PRODUCT UPDATE

Number: 154
By: Applications Engineering Dept.
Date: October 2, 2015

New! Aluminum Corrosion Resistant M Series Connectors

New
NiCorAl™
plating on
aluminum
alloy ("I"
code)

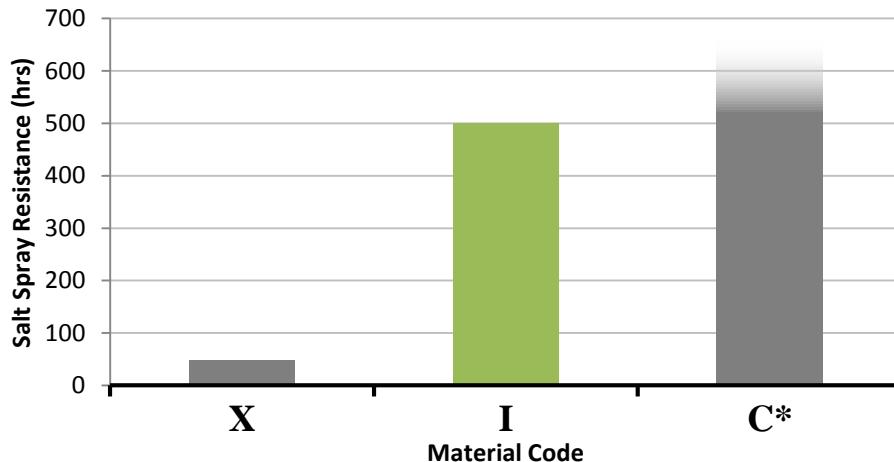
- 1) A new material code option has been added to the M Series selection: NiCorAl™ plating on the same Aluminum alloy shells as the standard "X" code. The NiCorAl™ plating, designated "I" code, is matte gray in color, similar to the standard "X" code plating. It is also electrically conductive (**<1.5 $\mu\Omega$ shell-to-shell resistance**), so shielding is preserved.

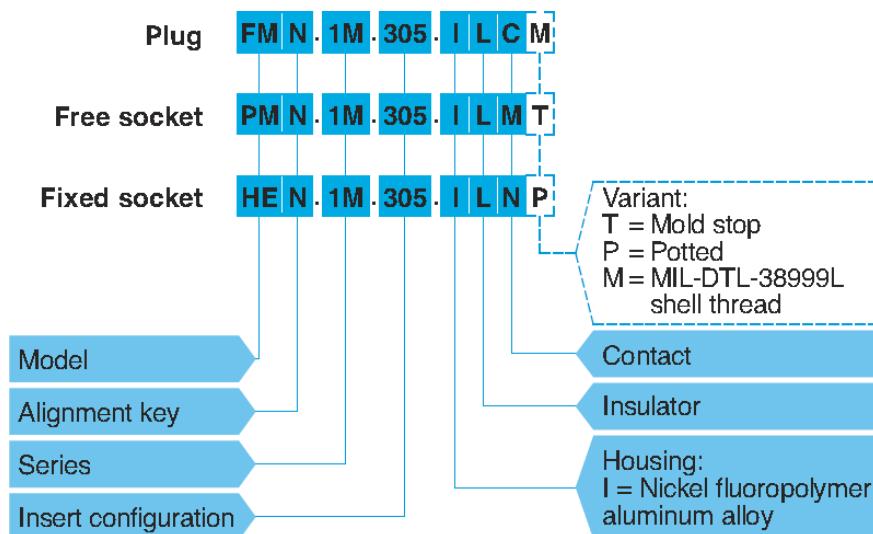
- 2) As is true with all LEMO products, connectors with the new "I" material code are both RoHS and REACH compliant.
- 3) The NiCorAl™ plating upgrade increases the salt spray corrosion resistance to 500 hours, up from 48 hours for the standard "X" code plating.

- 4) All previous configurations are available with the "I" material code. Only the housing material code changes in the part number. Please ask Applications Engineering if there are any questions.
